Access Compliance Report

Public Rights-of-Way

(Curb Ramps)

Intersection ID: 43205	Main Street: SILVERSWORD_DR	Cross Street: PLUMLEAF_DR	Location: SW
ADA ID: 2DA3CFD48CD8	Ramp Type: PerpDiag	Initial Pass/Fail: Fail	Overall Compliance: No
Severity Score: 22.5			
Codes/Mitigation Info/Possible Solution		Field Measurements/Component Compliance

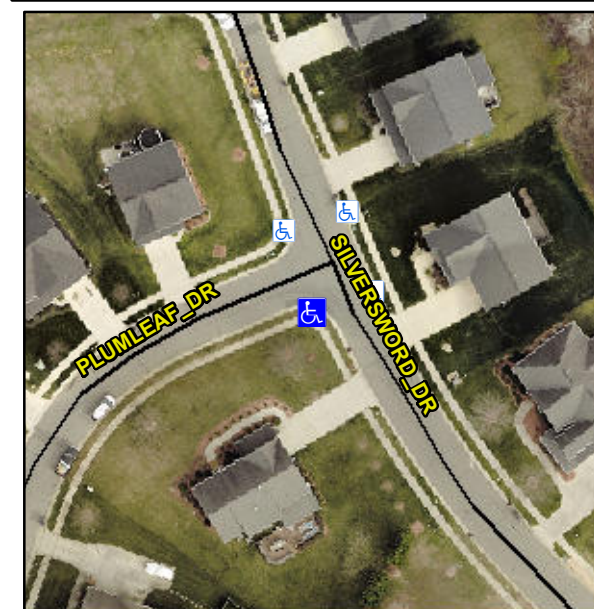
Not Found, R304.5.1, R304.2.2, R304.5.3

Compliance	Description	Data	Compliance	Description	Data
N/A	Ramp Length (in)	45.5	No	Ramp Slope (%)	8.5
No	Ramp Width (in)	47.5	No	Ramp XSlope (%)	4.3
N/A	Flare Type LT	N/A	N/A	Flare Type RT	N/A
N/A	Flare Slope LT (%)	N/A	N/A	Flare Slope RT (%)	N/A
N/A	Flare Traversable LT?	N/A	N/A	Flare Traversable RT?	N/A
N/A	Landing Length (in)	N/A	N/A	DWS Provided?	N/A
N/A	Landing Width (in)	N/A	N/A	DWS Contrast?	N/A
N/A	Landing Slope (%)	N/A	N/A	DWS Length (in)	N/A
N/A	Landing X Slope (%)	N/A	N/A	DWS Full Width?	N/A
N/A	Landing Curb? (Y/N)	N/A	N/A	DWS Offset (in)	N/A
N/A	Shared Landing?	N/A			
N/A	Gutter Ponding?	N/A	N/A	Gutter Slope (%)	N/A
N/A	Gutter Lip Ht (in)	N/A	N/A	Gutter X Slope (%)	N/A
N/A	Painted X Walk1?	No	N/A	Painted X Walk2?	No
	X Walk 1 Direction	To E		X Walk 2 Direction	To N
N/A	X Walk 1 Width (in)	N/A	N/A	X Walk 2 Width (in)	N/A
	X Walk 1 Slope (%)	4.6		X Walk 2 Slope (%)	2.0
	X Walk 1 X Slope (%)	2.2		X Walk 2 X Slope (%)	1.9

Remove & Replace Curb Ramp With Two New Directional Ramps or Equivalent.
